SIR JOHN SOANES MUSEUM
OPENING UP THE SOANE PH 4

WILD ANTE ROOM DRG NO. 506MP4/DD014A
(13mG/12) REF. CEILING SCALE 1:20 @ A3
PLAN AS PROPOSED DATE NOV. 2009

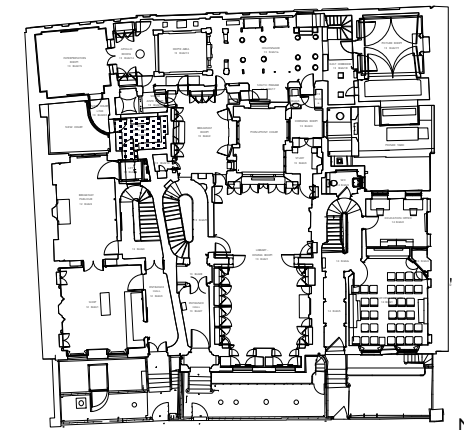
DRAWING REVISIONS:
Rev. A: Nov. 2014: Repair of mitre joints added.

- ③ Existing architectural elements of the ceiling (high-level shelf, frieze, decorative ceiling ground and rooflight to be retained, un-altered).
- ④ Splines in mitre joints (say 10mm).
